**Re: Pio Pico Energy Center Project (11-AFC-01)
Additional Information Submitted to USEPA**

Subject: Pio Pico Energy Center PSD Permit Application
Modeling Questions

As requested by EPA in the December 9, 2011 meeting between representatives of EPA and Pio Pico Energy Center, LLC (Applicant), we are herein submitting additional information on behalf of Applicant. Specifically, EPA requested additional analysis and information to support the modeling performed for the Pio Pico PSD Permit Application.

Figure 2
Wind Rose, Otay Mesa International Border Crossing Meteorological
Monitoring Station, 2006-2008

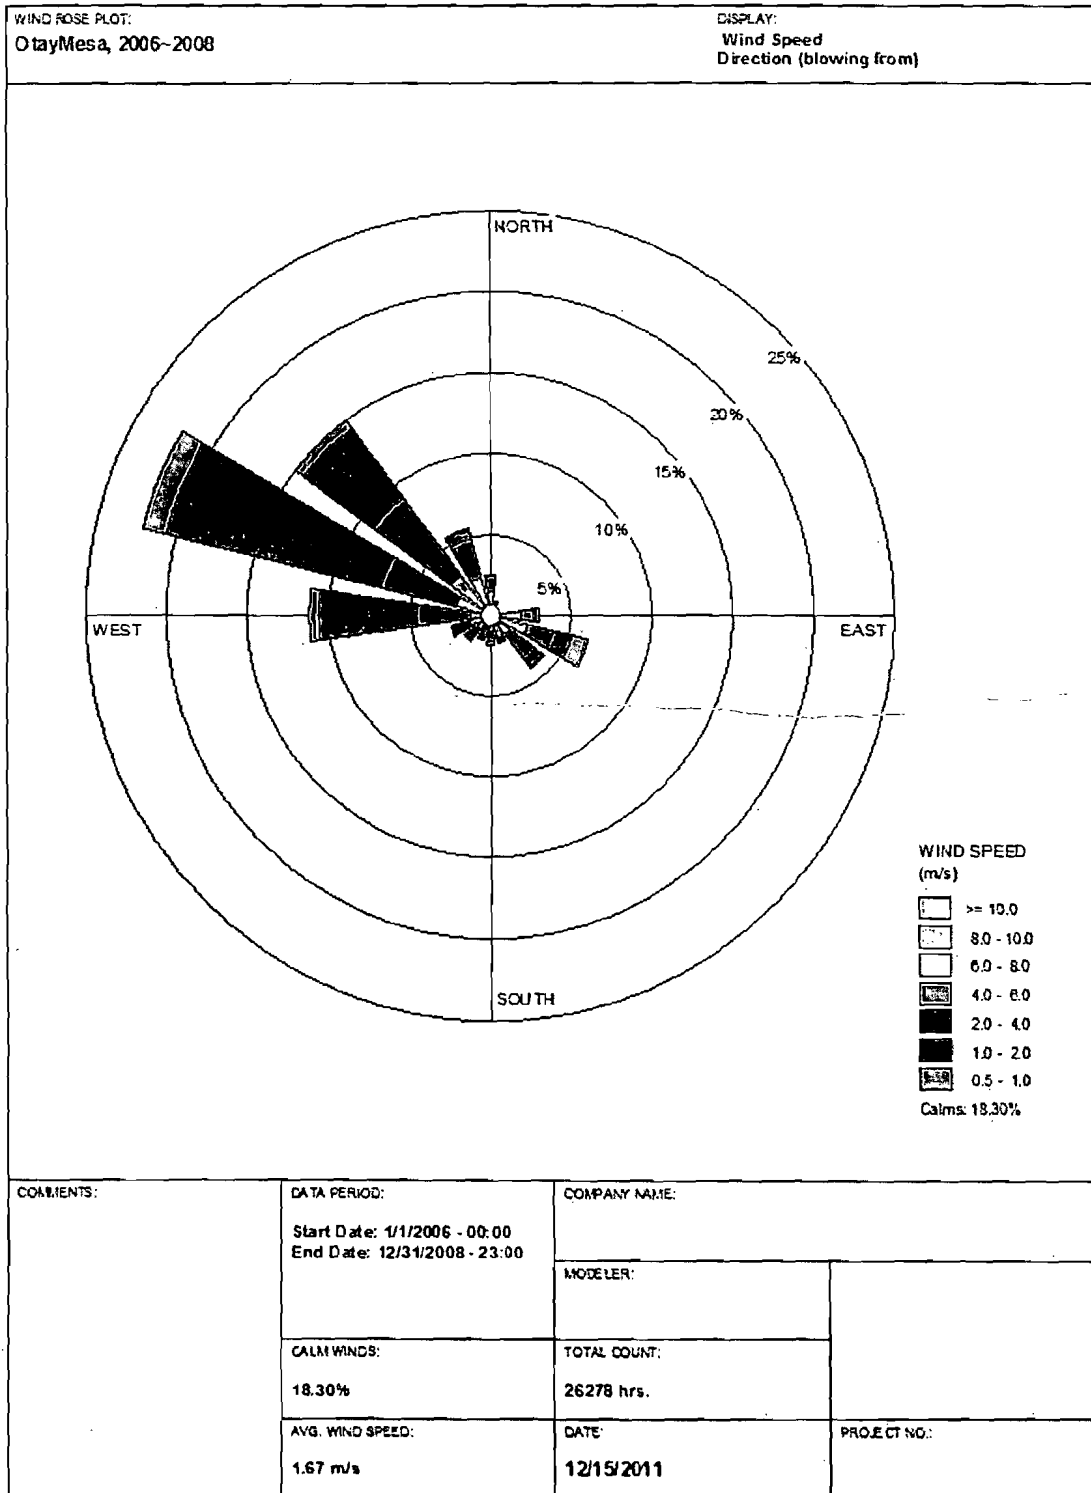
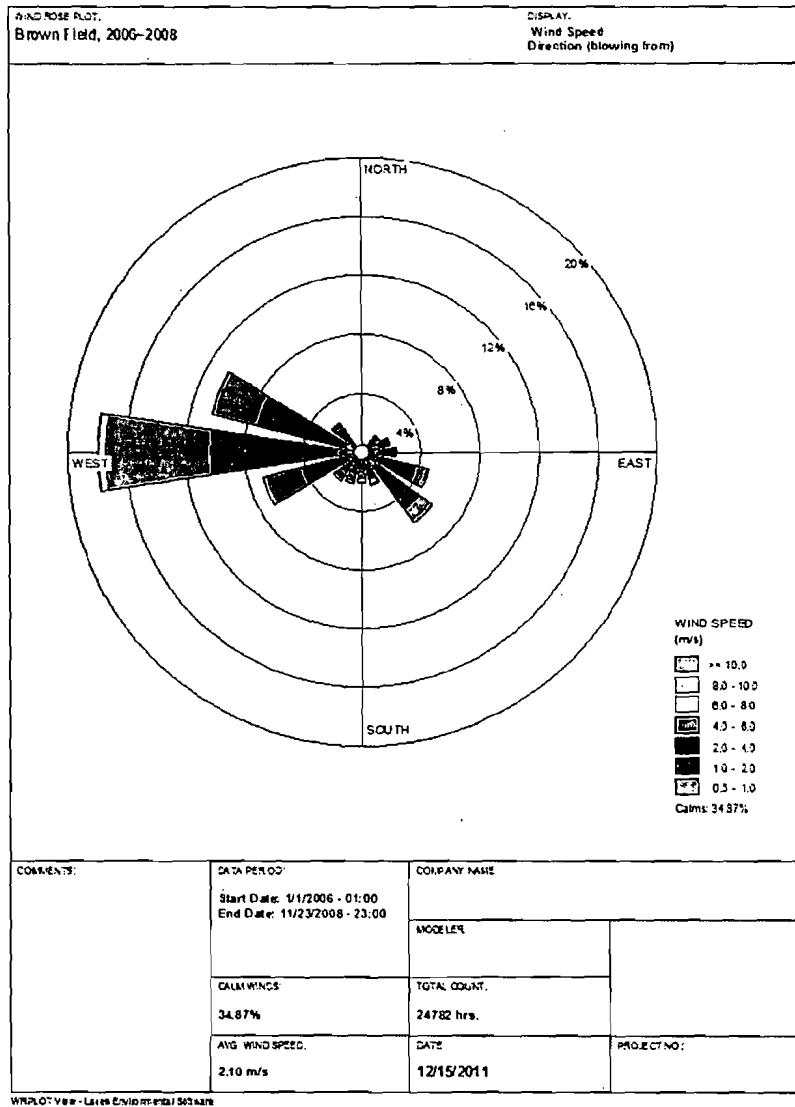
Comment: *Justify the use of Otay Mesa meteorological data to characterize conditions in the project area:*

Response: The following discussion is based on criteria described in Section 3.1 (Representativeness) in EPA's Meteorological Monitoring Guidance for Regulatory Modeling Applications (February 2000).

As can be seen in Figure 1, the Project site, the Otay Mesa monitoring site, and Brown Airfield, from whose meteorological monitoring station the few substituted meteorological data were obtained, are all situated on the same flat mesa within three miles of each other. The Otay Mesa monitoring site is less than two miles from the project site. Air flow over all three locations is sufficiently identical to consider meteorological data monitored at the International Border Crossing to represent the meteorological conditions at the project site (see wind roses for Otay Mesa and Brown Airfield monitoring data in Figures 2 and 3, respectively). Wind speeds at the Otay Mesa monitoring site are somewhat slower than those at Brown Airfield, leading to more conservative air quality concentrations computed by AERMOD from Project emissions.

Consistency would call for site selection criteria consistent with the steady-state assumption; i.e., to the extent possible, sites should perhaps be selected such that factors that cause spatial variations in meteorological conditions are invariant over the spatial domain of the application, whatever that might be. Such factors would include surface characteristics such as ground cover, surface roughness, the presence or absence of water bodies, etc. Similarly, the representativeness of existing third-party databases should be judged, in part, by comparing the surface characteristics in the vicinity of the meteorological monitoring site with the surface characteristics that generally describe the analysis domain.

**Figure 5
Turbine Efficiency Curves**

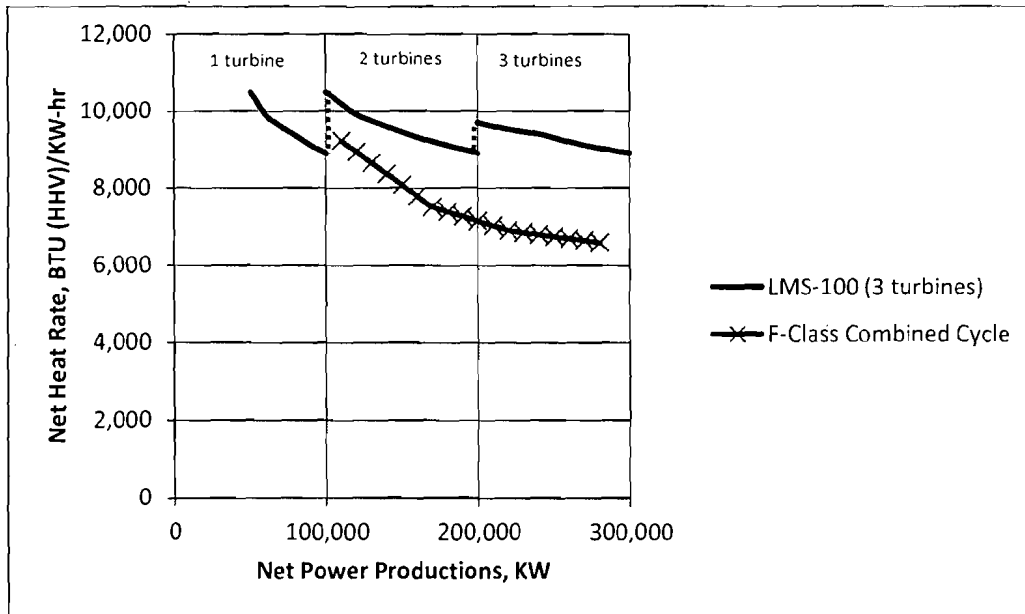
Comment: *In Step 4 of the BACT analysis, Applicant made the following statement: "A larger-capacity unit would be operated at less than optimum (full) output more frequently than a smaller-capacity turbine, and since gas turbine efficiency drops rapidly at less than full load, this mode of operation would likely reduce the overall efficiency of the combined-cycle units to below that of the proposed simple-cycle gas turbines." Please provide the basis for this claim.*

Response: As shown in Figure 5, turbine efficiency drops rapidly at less than full load. A single, high-efficiency combined-cycle unit (such as an F-class unit in a 1x1 configuration) cannot effectively operate through the broad range of loads that multiple simple-cycle units can.⁷ Figure 5 compares the efficiency curves for the proposed LMS100 configuration with an F-class combined cycle unit (GE S107FB). It is important to note that while the LMS100 configuration provides the flexibility to operate across the full range of loads between approximately 50 MW and 300 MW, it will most likely be dispatched to operate at the more efficient loads of 100 MW, 200 MW or 300 MW.

⁷ As designed, PPEC is capable of providing load-following capability from a minimum of 50 MW up to its full capacity of 300 MW. The GE S107FB is limited to a range of approximately 110-280 MW. The broader range of response is an important feature of PPEC's proposal to SDG&E.
